Memorandum

Project: 87-131 Bell Street, Ivanhoe
Our Ref: G25654M-02A
Date: 6th August, 2019

**RE: Response to Council's Memorandum prepared by One Mild Grid (dated 11th July, 2019)
Proposed Mixed Use Development at 87-131 Bell Street, Ivanhoe**

Figure 2: Post-development peak hour traffic volumes

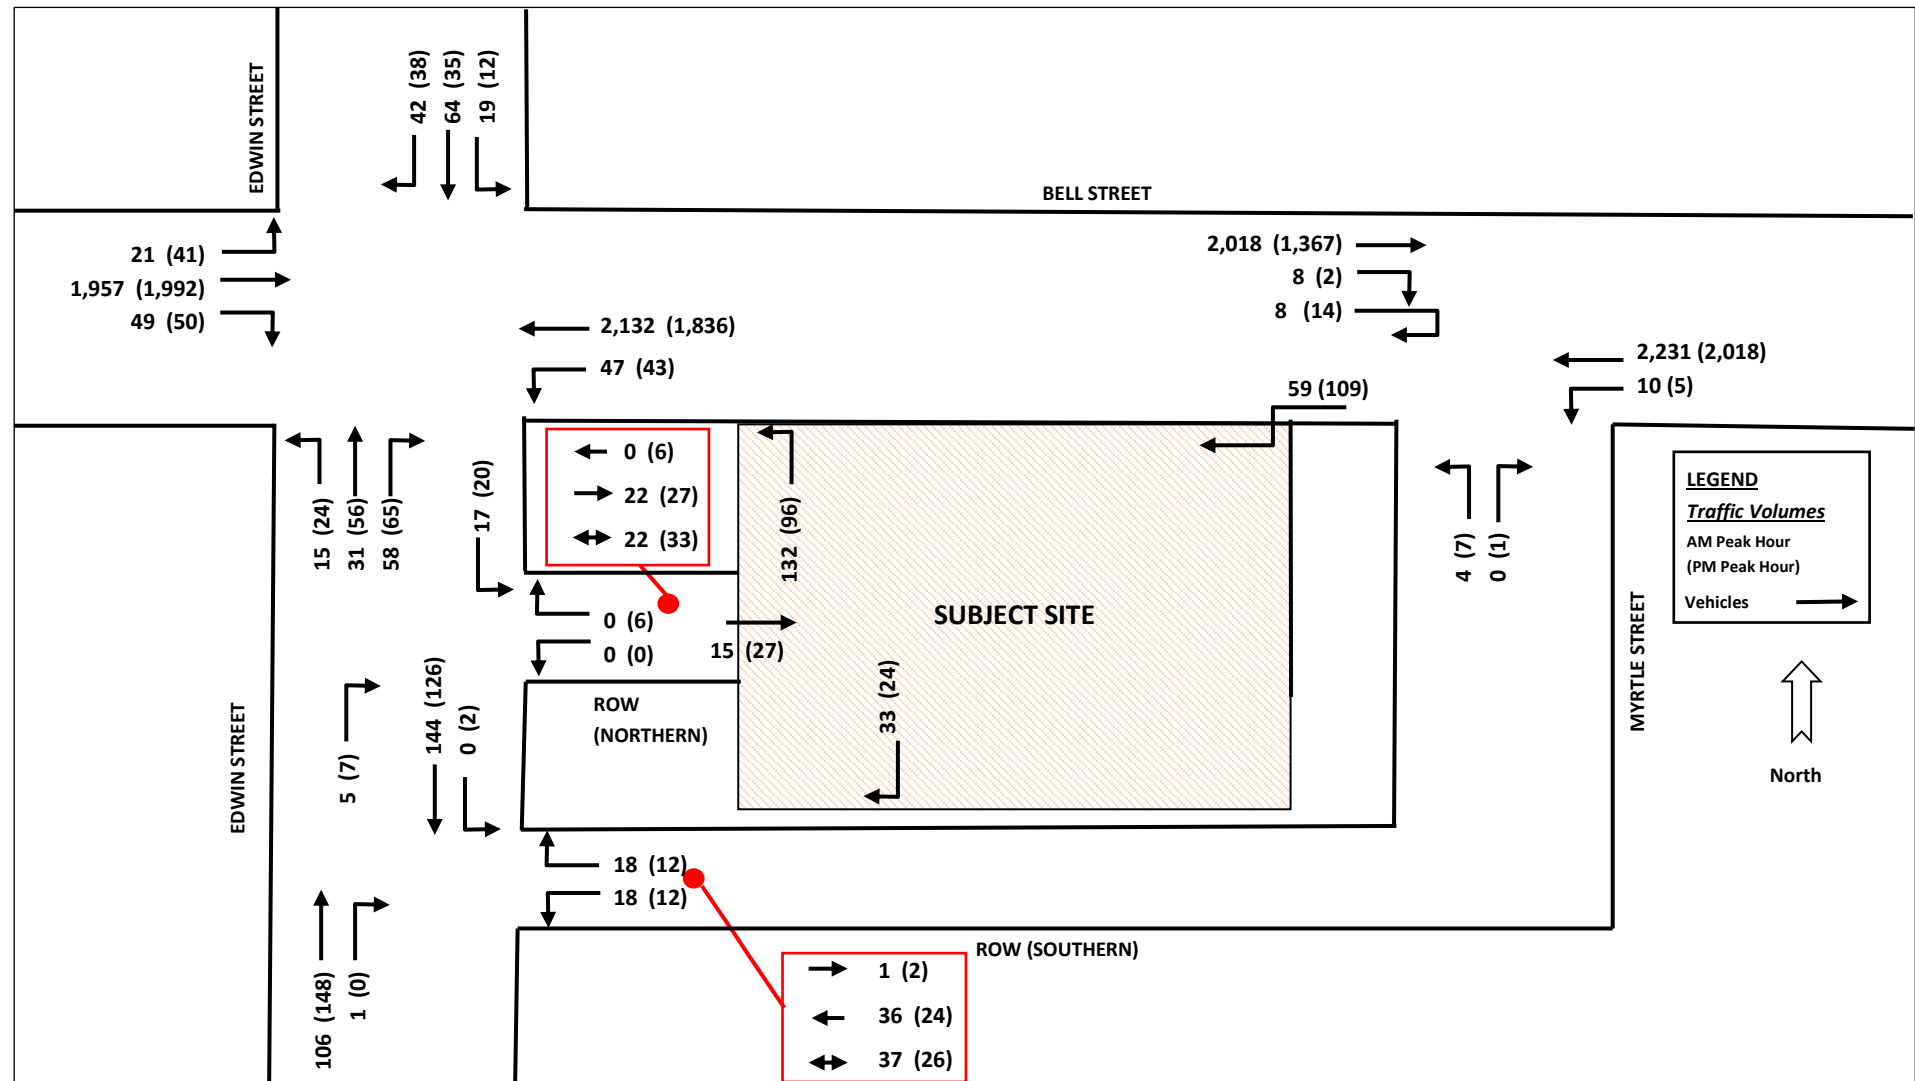
It should be noted that the Planning Scheme identifies the indicative capacity of the RoW as 300 vehicles per day. It is typically accepted that peak hour volumes represent 10% of the daily traffic volumes for a street, and the Traffix report projects a PM peak hour volume of 35 vehicle movements along the northern RoW. It can therefore be determined that the expected post-development daily traffic volumes of the northern RoW will exceed the indicative capacity. It is recommended that a vehicle conflict analysis be undertaken to understand the probability of two opposing vehicles meeting along the northern RoW and subsequently, how many vehicles would be required to queue as a result of a conflict.

As detailed previously, Council's traffic referral outlined some concerns regarding the capacity of the northern and southern ROW's to accommodate the post-development traffic volumes.

Based on the updated post-development traffic volumes forecast at Section 3.1 and shown at Figure 2, it is expected that in the PM peak hour, there will be a two-way volume of 33 vehicles, comprising 27 'inbound' movements and 6 'outbound' movements. All 27 inbound movements will relate to site generated traffic. This level of traffic is marginally above the threshold to provide for two-way passing opportunities, as directed by AS2890.1-2004. Lower volumes are expected in the AM peak hour.

Based on a review of our conflict data, an average of 1.2 conflicts are expected within the northern ROW across the PM peak hour.

Based on the updated post-development traffic volumes forecast at Section 3.1 and shown at Figure 2, it is expected that in the AM peak hour, there will be a two-way volume of 37 vehicles, comprising 1 'inbound' movement and 36 'outbound' movements. 33 of the 36 outbound movements will relate to site generated traffic. This level of traffic is marginally above the threshold to provide for two-way passing opportunities, as directed by AS2890.1-2004. Lower volumes are expected in the PM peak hour, which will be within this threshold.

Based on a review of our conflict data, an average of 1.6 conflicts are expected within the southern ROW across the PM peak hour.
